# CITY OF ALBUQUERQUE

**RE: 1401 Wyoming Blvd NE - Maverick**  
**Grading Plan Engineer's Stamp Date: 2/25/2019**  
**Drainage Report Engineer's Stamp Date: 2/6/2019**  
**Hydrology File: J19D049**

Based upon the information provided in your submittal received 2/6/2019 and 2-25-2019 and the SWQV Payment in-lieu of \$4376.00, the Grading and Drainage Plan is approved for Building Permit, and/or Grading Permit.

**MAVERIK**  
1401 WYOMING BLVD. NE  
**GRADING AND DRAINAGE PLAN**

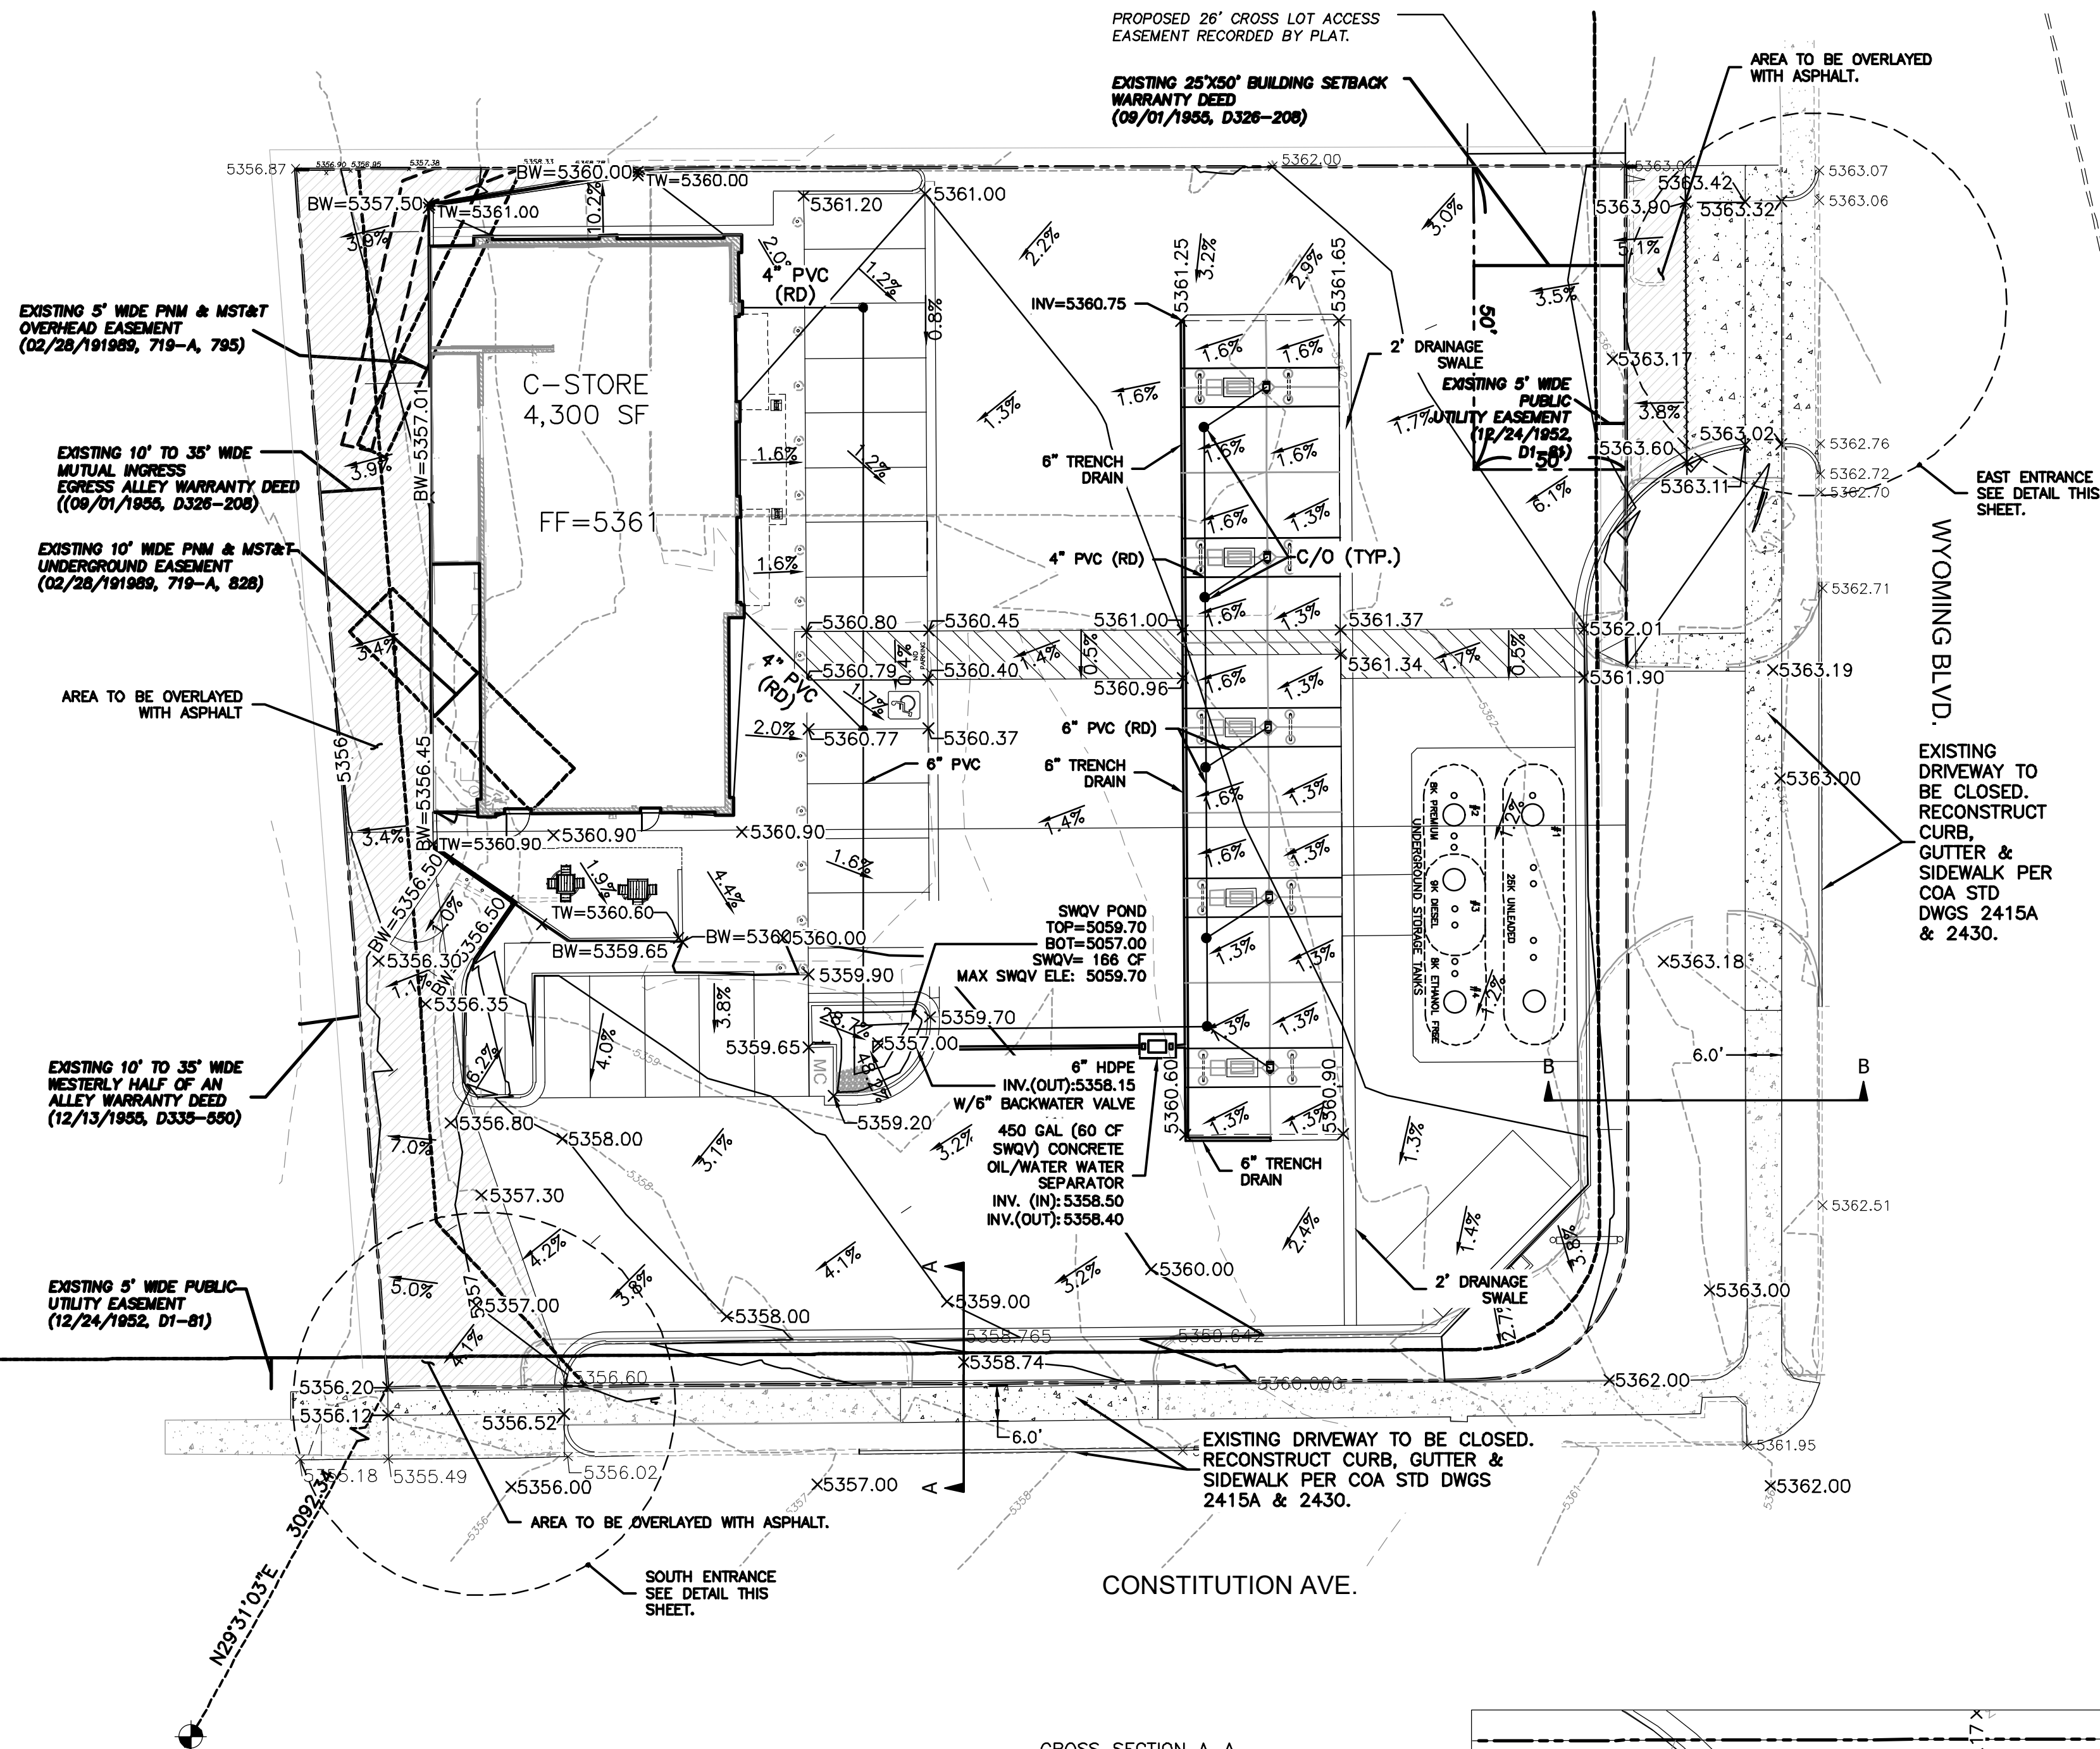
Please attach a copy of this approved plan in the construction sets when submitting for a building permit. Prior to Certificate of Occupancy release, Engineer Certification per the DPM checklist will be required.

Please provide a Drainage Covenant for onsite inlets, storm drains, oil/water separator, and BMPs prior to Certificate of Occupancy. Please submit this on the 4th floor of Plaza de Sol with a \$25 check payable to Bernalillo County.
